SUBJECT: TURKEY POINT UNITS 3 AND 4 - ISSUANCE OF AMENDMENTS RE: BORIC
ACID CONCENTRATION REDUCTION (TAC NOS. 79192 AND 79193)

AMENDMENT NO. 144 TO FACILITY OPERATING LICENSE NO. DPR-31-TURKEY POINT UNIT 3
AMENDMENT NO. 139 TO FACILITY OPERATING LICENSE NO. DPR-41-TURKEY POINT UNIT 4

SAFETY EVALUATION BY THE OFFICE OF NUCLEAR REACTOR REGULATION
RELATED TO AMENDMENT NO. 144 TO FACILITY OPERATING LICENSE NO. DPR-31
AND AMENDMENT NO. 139 TO FACILITY OPERATING LICENSE NO. DPR-41

TURKEY POINT UNIT NOS. 3 AND 4

Figure 3.1.2.5

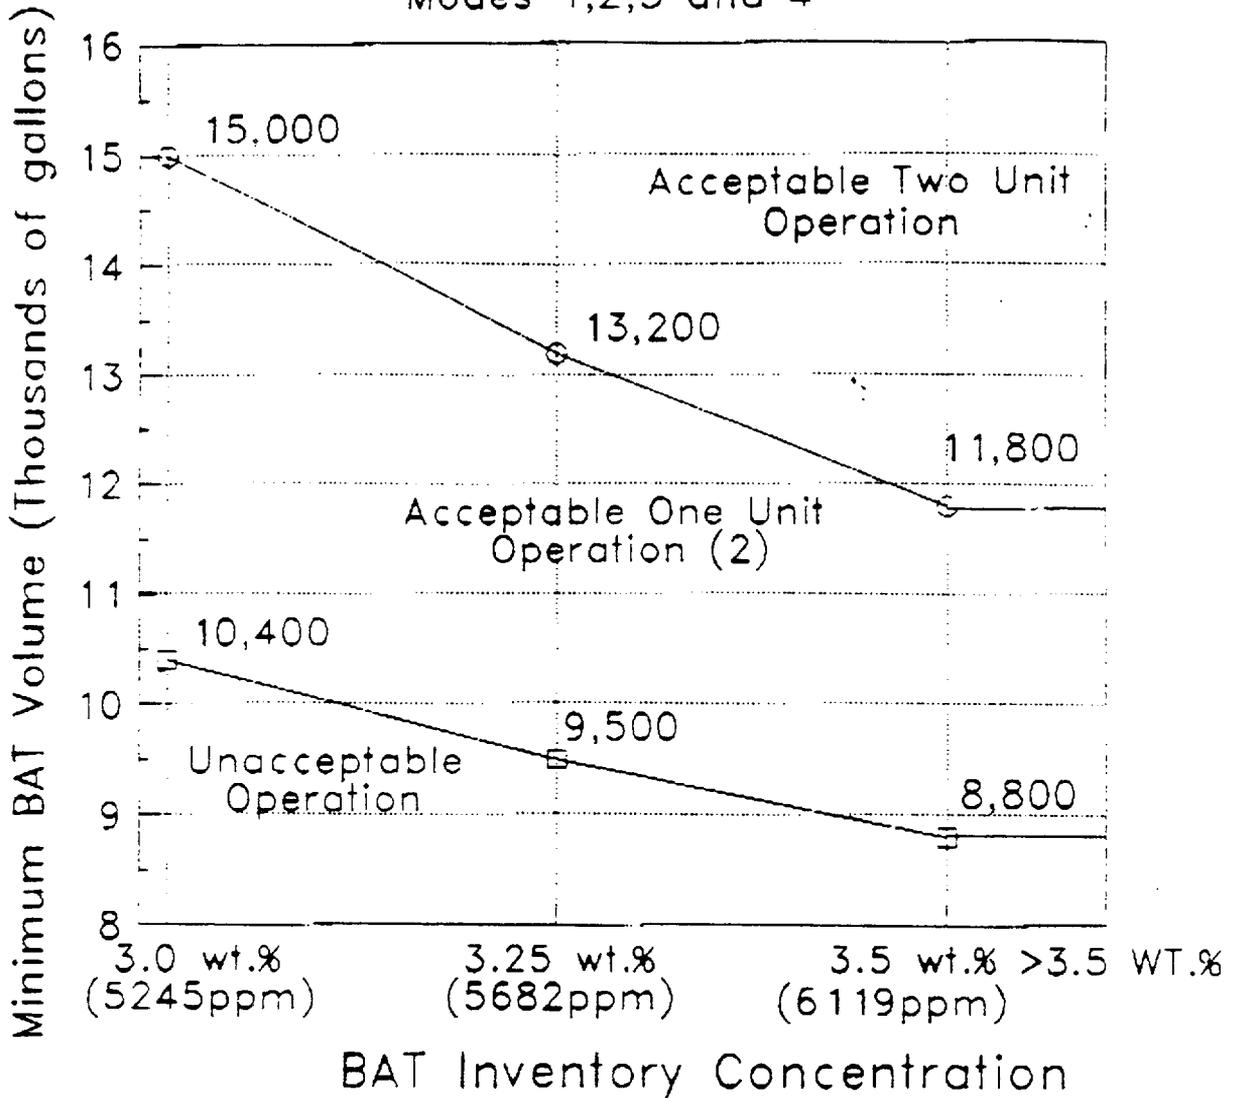
The planned reduction in BAT boron concentration (from 20,000 ppm-22,500 ppm boron to 3.0 wt% (5245 ppm) - 3.5 wt% (6119 ppm) (boron)) requires that all TS containing the current values be revised to reflect the new values. Similarly, the corresponding increase in delivery capacity from 4 gpm to 16 gpm (discussed in 2.2.2 above) requires the appropriate TS revisions. The following TS are affected by these changes: 3.1.1.1, 3.1.1.2, 4.1.2.2.c, 3.1.2.4.a.2, 3.9.1, 3.10.1 (a and b), 3.1.2.5.a (1 and 2), and the associated Bases sections. Figure 3.1.2.5 has been added to TS 3.1.2.5 to define the new BAT operability

requirements for volume and concentration. The volumes represented in the figure are the combined volumes of the three BATs, with allowance for minimum required volume for two operating units in Modes 1 through 4 and for one operating and one shutdown unit in Modes 5 and 6. For the shutdown unit, the minimum BAT volume required to provide a shutdown margin of 1% $\Delta k/k$ during cooldown from 200°F to refueling temperature, as specified in TS 3.1.2.4.a.1 (and associated Bases section) is changed from 500 gallons to 2900 gallons.

- a. A Boric Acid Storage System with:
 - 1) A minimum indicated borated water volume in accordance with Figure 3.1.2.5,
 - 2) A boron concentration in accordance with Figure 3.1.2.5, and
 - 3) A minimum boric acid tanks room temperature of 55°F.
- b. The refueling water storage tank (RWST) with:
 - 1) A minimum indicated borated water volume of 320,000 gallons,
 - 2) A minimum boron concentration of 1950 ppm,
 - 3) A minimum solution temperature of 39°F, and
 - 4) A maximum solution temperature of 100°F.
